CSB-1384-2
 Country : UK
 Date : 7/6/2007
 APC : G33
 Repair Level : 2

Title W510 - GSM - Hinge flex open trace issue
 Model Effected W510

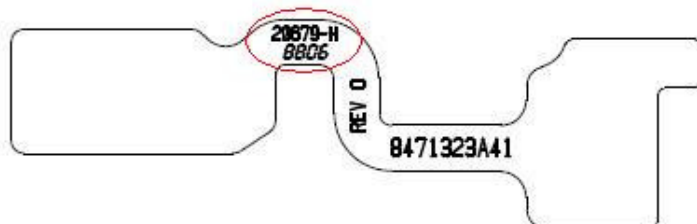
Service has been made aware of a hinge flex open trace issue during W510 NPI analysis. Some W510 units returned with customer complaints of "Audio, earpiece no", "Alert, ring tone no" or "Display main, no display", we found one common root cause - hinge flex open trace. High impedance or open can be measured from pins which related with ring tone, speaker or LCD data lines. Base on X_Ray analysis, surface nick can be observed at the trace layers. The surface nick is caused by air bubble entrapped between base copper and dry film.

The supplier has optimized the dry film lamination setting temperature. Change of the temperature setting for dry film lamination top platen temperature from 70C to 60C. Also implemented 100% AOI on all the layer by Installing a mirror image on the AOI machine from week25,2007.
